Intel[®] StrongARM[®] SA-1100 Evaluation Platform

Specification Update

December 1999

Order Number: [278246-005](#)

Figure 1. Ejector Mechanism

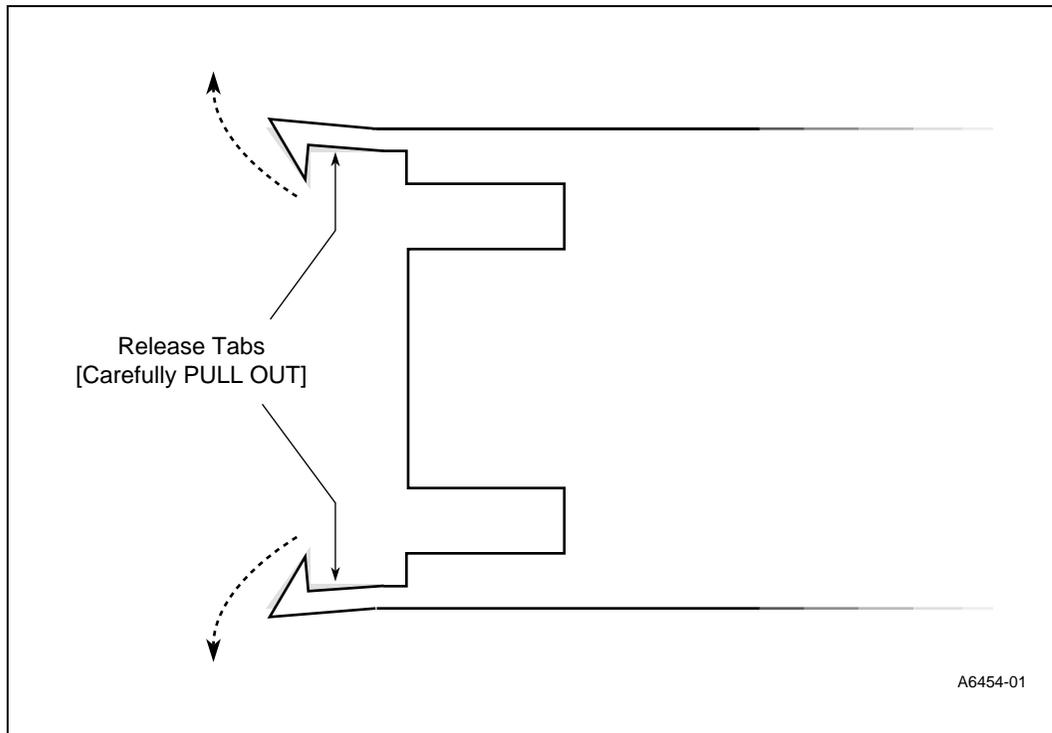
Problem: The PCMCIA ejector mechanism can short to a via on the board of the SA-1100 evaluation platform when a PCMCIA card is installed.

Implication: The SA-1100 evaluation platform will not work properly and could become damaged if a PCMCIA card is installed.

5. Place a small flat tipped screwdriver under the black locking tabs, which are located just above the “41” of “TP 41.” Gently pull the tabs out by twisting the screw driver (see [Figure 1](#)) while rocking and pulling the ejector mechanism towards the right-hand edge of the board. Be careful to lift the ejector over C17.

Workaround: Use the following procedure to insulate the via's on the board of the SA-1100 evaluation platform:

1. Power down the SA-1100 evaluation platform.
2. Remove the following cables from the SA-1100 evaluation platform:
 - J27–LCD cable (side 2, back-left corner)

- J3–Touch screen cable (side 1, back center)
 - J6–Backlight inverter cable (side 1, back-right corner)
 - J25, J26–Keyboard cable (side 1, front-center) note unused pins on pins 1, 2, 3, of J25 and on pins 15, 16, 17 of J26

3. Remove the six screws from the SA-1100 evaluation platform that attach it to the base.
4. Remove the two screws attaching the PCMCIA ejector mechanism from the SA-1100 evaluation platform (nuts are located on side two).
